Re: *Nez Perce Tribe's objection to Hungry Ridge Restoration Project Final Environmental Impact Statement and Draft Record of Decision*

**NEZ PERCE TRIBE'S OBJECTION TO THE HUNGRY RIDGE RESTORATION
FINAL ENVIRONMENTAL IMPACT STATEMENT and
DRAFT RECORD OF DECISION**

b. **Erroneous sediment analysis.**

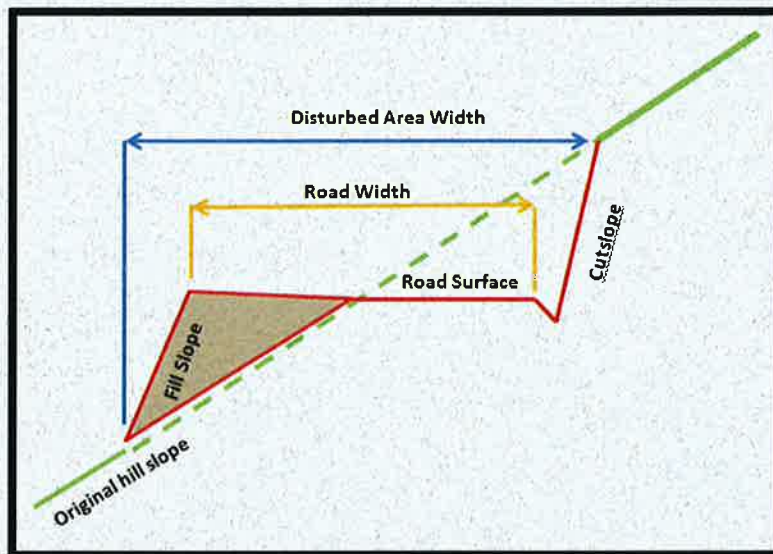
The Tribe has serious and immediate concerns about the NEZSED results that were generated and the results that have been presented in the FEIS, which ultimately have been used heavily in the decision to move forward with Alternative 2, are incomplete and/ or inaccurate.

Errors contained in the tabs of the NEZSED spreadsheet show the Forest used incorrect and incomplete data to generate the NEZSED model calculations in the FEIS. "RoadsCumulative", "RoadCumulative8.13", and "RoadAlt2" appear to have subgrade widths that are substantially and

unrealistically low (in many instances a default width of 10 feet is used), resulting in disturbed road widths that are too low, based on the *Nez Perce National Forest Watershed Data Base Horizontal Width of Disturbance for Roads* document (U.S. Forest Service 1987) and previous NEZSED completed on other projects, namely the most recent Clear Creek Integrated Restoration Project. In addition, in the “RoadAlt2” table, the sideslope field is left unpopulated, which appears to compound the error resulting in disturbed road widths that are far too low. These fields are used in the calculations that ultimately result in acceptable POB values in the FEIS. It is of concern to the Tribe that the erroneous and missing values in the NEZSED spreadsheet appear to be presumably correct in the DEIS when the sediment yields calculated far exceeded the Forest Plan guidelines but no longer represent realistic disturbed road width values in the FEIS calculations when the sediment yields calculated fall within acceptable Forest Plan guidelines.

Width of disturbed area includes: subgrade, cut and fill slopes, ditches, berms, turnouts, and any other constructed features when present (Cline et al 1981). Using the tables of geometry in Megahan 1976 as recommended in R1R4 guide, and assuming a road width of 16’ with no ditch or pull outs and adjacent slope of 60%, for example, the horizontal disturbed width would be 48’. Since many of the roads have turnouts and or ditches, this would be a conservative estimate of actual width of disturbed area. Tripling the width of disturbed area equates to a 350% increase in sediment.

Had the Forest accounted for the entire disturbed area, as required by the NEZSED model, the Tribe believes sediment production from roads will likely increase significantly. Comparing the DEIS and the FEIS values, aside from the other sediment-routing corrections that were made, would suggest the sediment delivery should be estimated much higher than shown in the FEIS using correct and complete data.

Remedy: The Tribe requests that the Forest correct its sediment analysis by performing full and accurate NEZSED modeling for the Project and document those results and environmental impacts, including to the Tribe's treaty-reserved fish resource, in a supplemental FEIS.
